# ADDENDUM NO. 1

**June 13, 2024**

## **PORTER COUNTY HIGHWAY DEPARTMENT – CENTRAL FACILITY**

This Addendum consists of Page ADD 1-1 through ADD 1-4, revised Specification Section 00 20 00 – Information Available to Bidders, attached Addendum No. 1 from A & Z Engineering, consisting of 1 page and 8 drawings, and attached Addendum No. 1 from MartinRiley, consisting of 4 pages, Specification Sections 00 01 10 - Table of Contents, 07 42 13 – Metal Wall Panels, 07 71 00 - Roof Specialties, 10 28 00 - Toilet, Bath, and Laundry Accessories, 11 11 19 - Vehicle Lubrication Equipment, 23 31 00 - HVAC Ducts and Castings, 41 22 00 - Hoists and Cranes, and 13 Drawings.

# A001

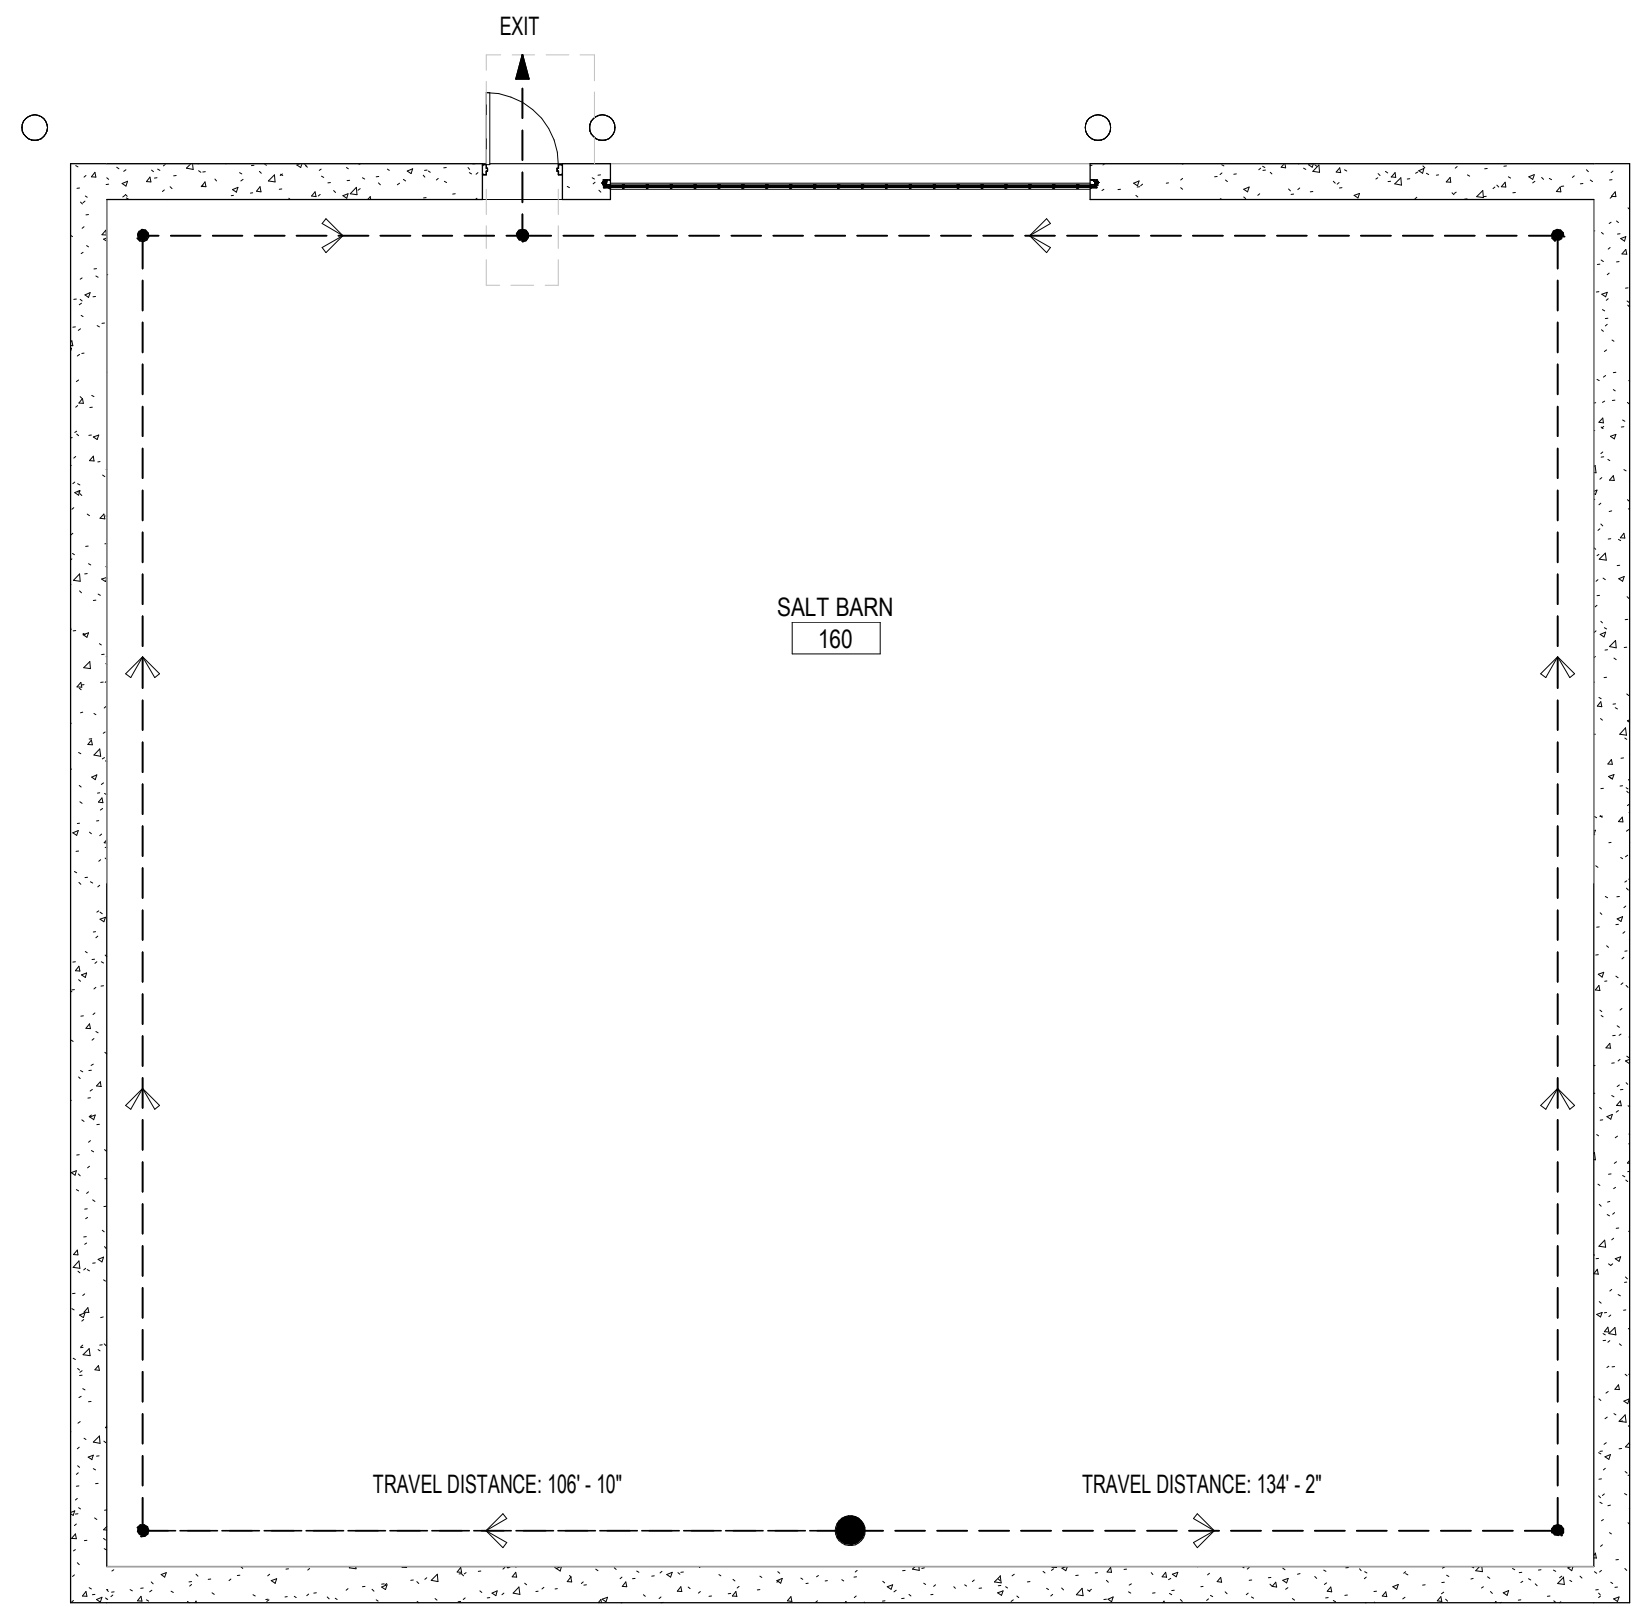
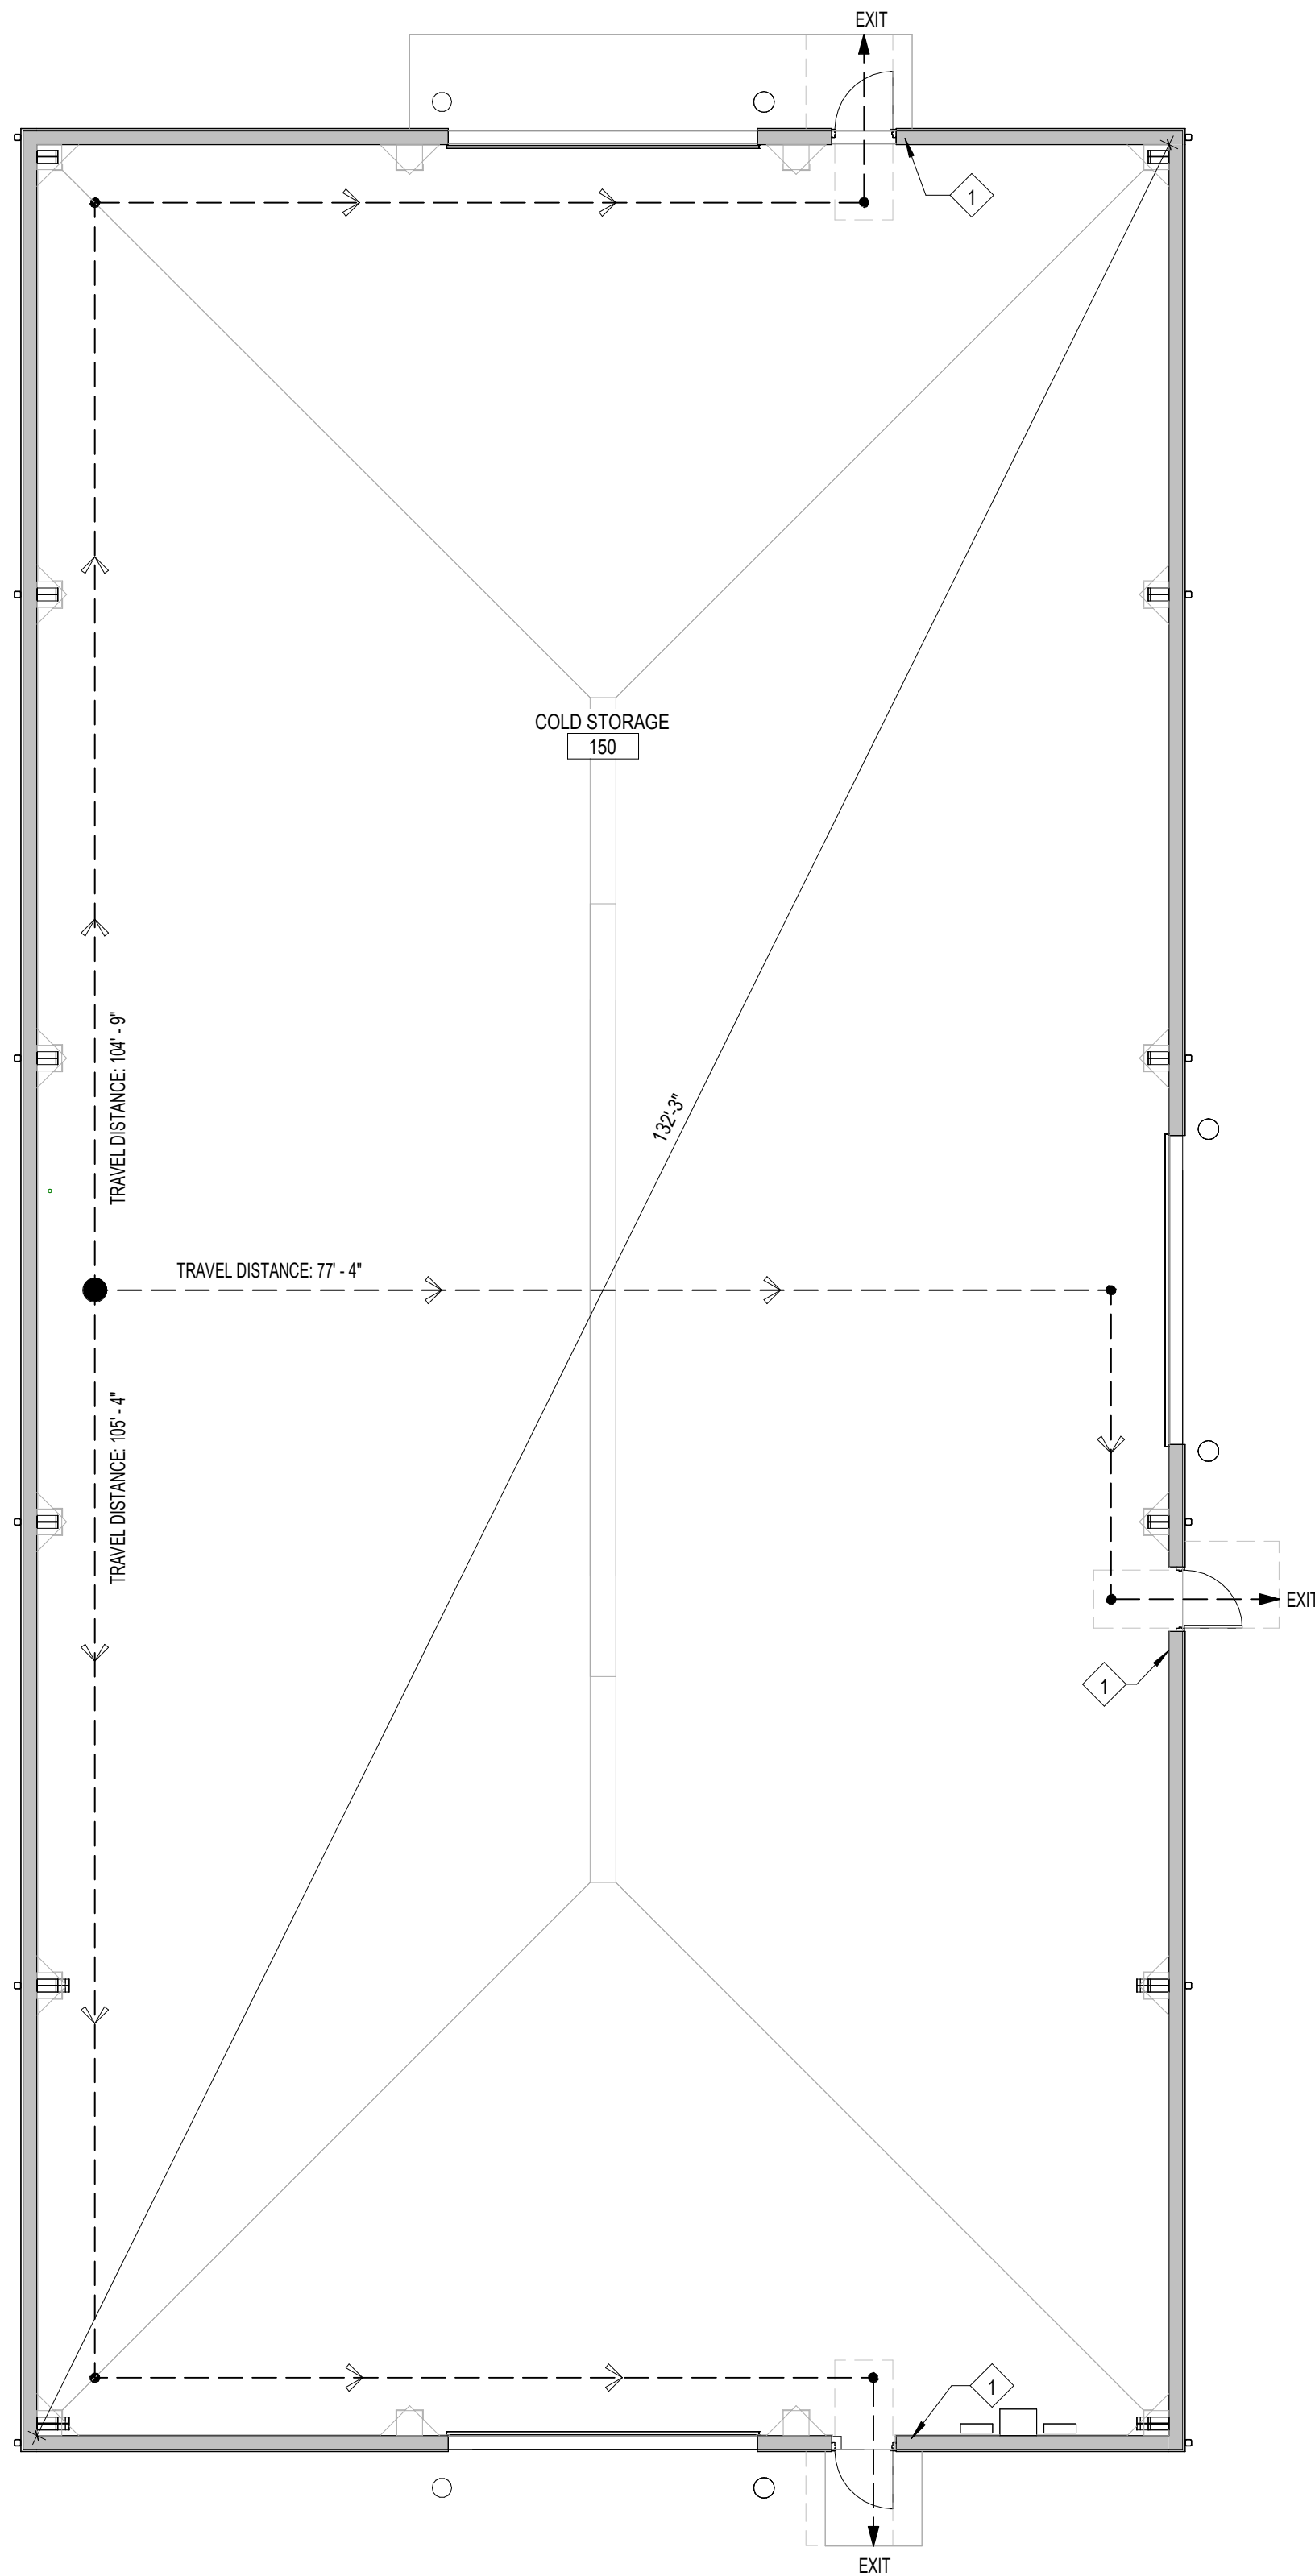
Sheet A001 Life Safety Plan - Central Facility **MODIFY** General Fire Protection Note 8. Add the following sentence to the end of the existing note. "Wash Bay 137 pipe and fittings to be galvanized."
